METROPOLITAN DEVELOPMENT COMMISSION

Case Number: 2025-CPL-825 / 2025-CVR-825

Property Address: 7140 and 7142 East Washington Street (approximate addresses)

Approval of a Subdivision Plat to be known as Wawa Shortridge Primary Plat, subdividing 9.4 acres into three lots.

Figure 744.701.05 Connector: Frontage Design & Building Placement & Form

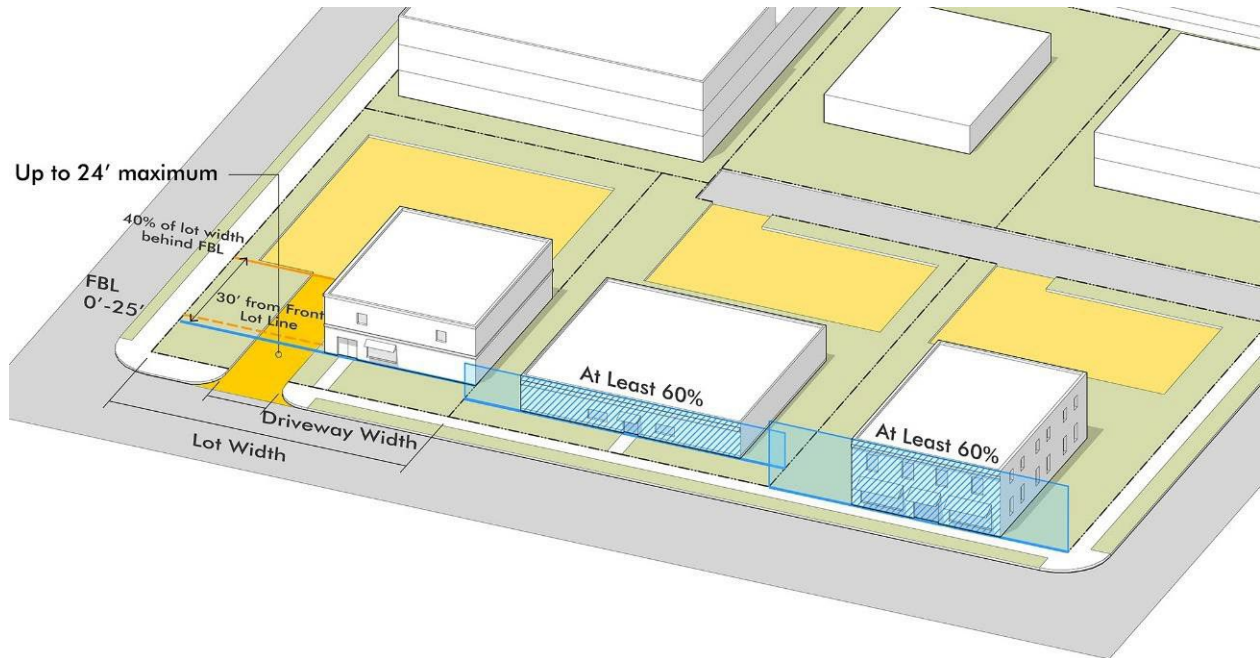
The petitioner is seeking relief from the requirement that surface parking areas be located entirely behind the front building line (FBL), with a minimum 25-foot setback from Washington Street. The submitted site plan depicts a parking area encroaching into the required setback, with certain parking spaces located within the front yard.

According to Table 744-402-1 of the zoning ordinance, the proposed 6,372 square-foot fueling station requires a minimum of 26 off-street parking spaces. The petitioner, however, is providing 62 spaces—more than double the required minimum. Staff finds that this surplus of parking indicates there is no true hardship necessitating the placement of parking within the front yard setback. By simply relocating the eight (8) electric vehicle (EV) charging spaces and two (2) regular spaces currently situated in the setback area to the rear of the site, the petitioner could maintain compliance with parking count requirements while adhering to the TOD Overlay’s form-based development standards.

The intent of these requirements is to maintain a pedestrian-oriented streetscape and prevent vehicular dominance along primary transit corridors. Allowing parking in the front yard would undermine this intent and detract from the urban design character the overlay seeks to establish.

Staff, therefore, **recommends denial** of this variance request as the petitioner has clear and reasonable options for compliance without undue hardship.

2025-CVR-825/ 2025-CPL-825 Old Elevations

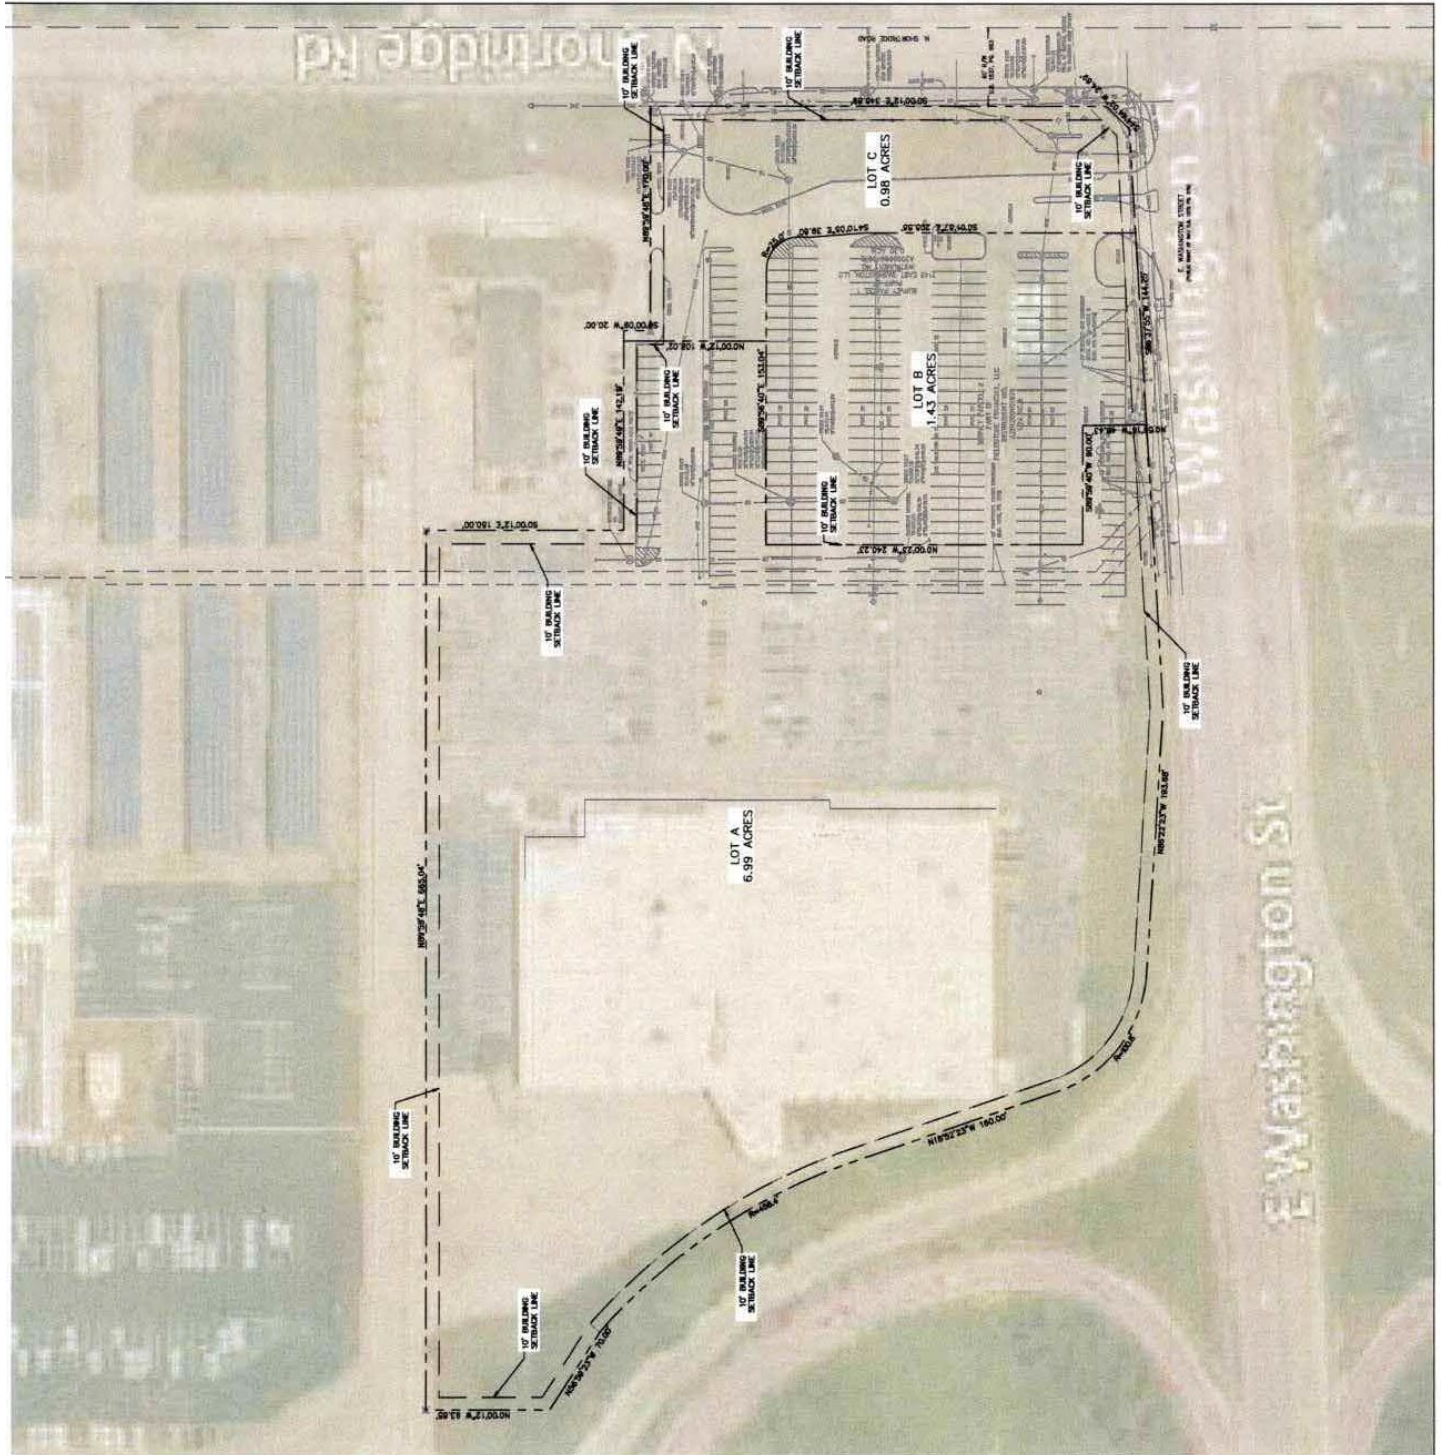
While transparency ratios improved, staff noted that much of the additional glazing is spandrel glass, which is opaque and does not count toward the transparency requirements. Staff recommends a commitment regarding that all glazing materials used meet the definition of transparency as outlined in the Zoning Ordinance.

The final variance request seeks relief from the Ordinance requirement that at least 40 percent of the wall surface area on all public-facing building facades between three and eight feet above grade be composed of transparent glazing. This standard is intended to ensure active, engaging frontages that support pedestrian interaction, safety, and visual interest along transit corridors.

As the subject property is located within both the C-4 zoning district and the Transit Oriented Development (TOD) Secondary District, both sets of standards apply. Specifically, the C-4 District Dimensional Standards require that any façade with a public pedestrian entrance, as well as any façade within 50 feet of an arterial street, maintain a minimum of 40 percent transparency within the defined area. In this case, both the northern and southern facades of the proposed building are affected by this standard.

The submitted building elevations indicate substantial non-compliance. The proposed design provides transparency ratios as low as 0 percent (right elevation) and 8 percent (rear elevation), with the front elevation providing only 25 percent transparent glazing—far below the required minimum. Furthermore, much of the glazing depicted on the elevations is spandrel glass, which does not meet transparency standards as it is opaque and does not allow visibility into or out of the building.

The petitioner has offered no compelling justification for retaining such a low level of transparency, and staff finds that allowing this variance would directly contradict the TOD Overlay’s pedestrian-oriented design objectives. Accordingly, staff **recommends denial** of this variance request and advises the petitioner to revise the building elevations to meet the transparency requirements outlined in both the TOD Overlay and the C-4 district standards.

2025-CVR-825/ 2025-CPL-825 PLAT

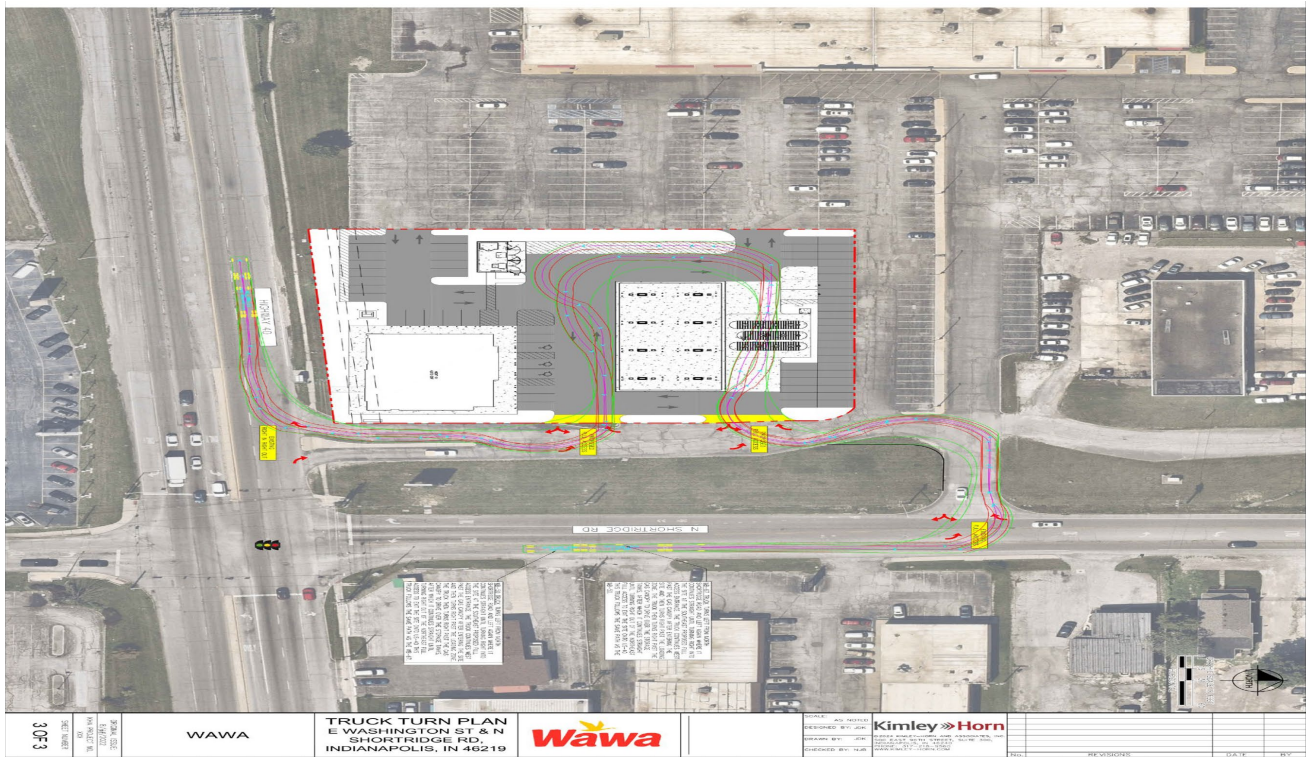
This petition requests the approval of a Subdivision Plat to be known as Wawa Shortridge Primary Plat, subdividing 9.4 acres into three (3) lots.

While the configuration appears to be crafted to technically avoid certain variance triggers, most notably the Front Building Line width requirement, it does so through the introduction of a shared parking easement. This easement appears to serve no functional shared purpose and instead functions primarily to reduce the frontage calculation of Lot 1. Staff does not support this approach, as it undermines the intent of the TOD Overlay's frontage requirements and circumvents the established form-based development expectations. A design that complies with the spirit and letter of the ordinance—rather than one that relies on artificial lot divisions—is strongly preferred

Staff's analysis indicates that this excessive parking width is a direct result of the lot's oversized frontage dimensions and the building's relatively narrow footprint. Specifically, the subject lot has a width of 209 feet, while the proposed building has a length of only 92.2 feet. According to the standards, a compliant lot would be no wider than 154 feet for the proposed building length.

Staff notes that this is a newly created lot as part of the accompanying companion plat petition, meaning its dimensions can still be revised. The petitioner could reduce the lot width by approximately 55 feet or increase the building width to better meet the frontage requirements. Both options are feasible given the site's size and context.
